Re: **Plan of Subdivision Application (07-T-20252)
Orchards of River Bend
Parts of Lot A & 1, Concession B and Part of closed road allowance between Lots A & 1
819 County Road 19, Township of Woford, Village of Merrickville-Woford
2873633 Ontario Inc. (Bill Kollaard)**

Technical Comments - Hazardous Lands

Project Name	819 County Road 23 / Burritts Rapids Road Subdivision
RVCA File ID	25-MWO-SUB-0010
RVCA File Lead	Eric Lalande
RVCA Review Date	5/9/2025
Previous RVCA Review Dates	na

Figure 1. Location and flow path of tributaries on the subject lands.

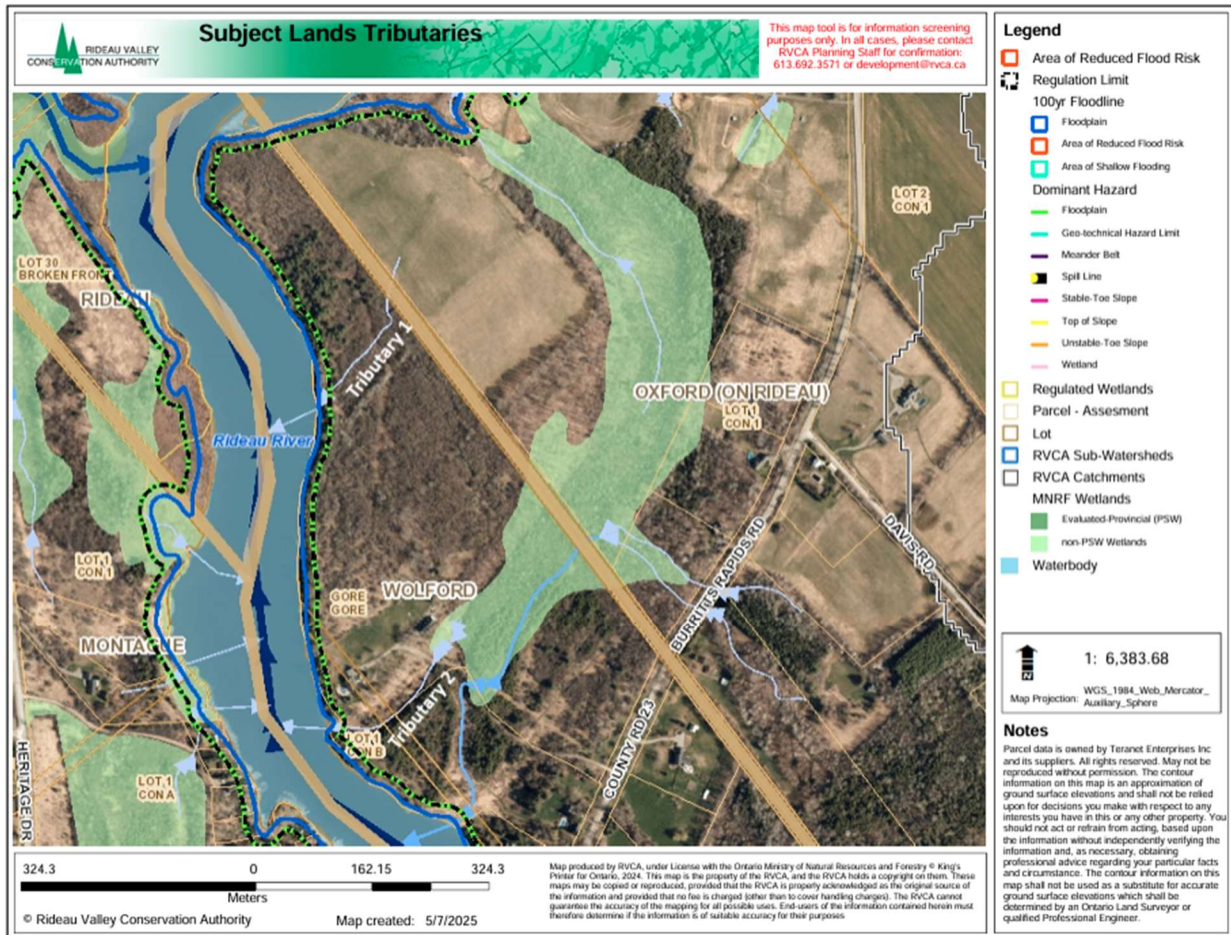
Tributary 1 appears to be flowing from a farm field which is adjacent to the unevaluated wetland and likely plays an important role in draining water off the subject lands during the spring freshet and large precipitation events. (See Figure 1) This tributary provides important storage to keep water out of the floodplain. The RVCA therefore recommends that the feature is maintained to preserve its hydrologic function and to mitigate the risk of flooding during peak flows.

- i) The RVCA recommends that Tributary 1 be maintained to facilitate drainage from the adjacent lands through the subject property and into the Rideau River. To

support the proposed lot layout, channel enhancements will likely be necessary - particularly at the downstream end. This may include modifications to the “crossings” to ensure adequate water passage.

- ii) The RVCA supports the recommendation to conserve Tributary 2. Ideally, this would involve channel enhancements guided by natural channel design principles. At a minimum, a 15-metre buffer of native vegetation should be established on both sides of the channel to provide long-term erosion control.
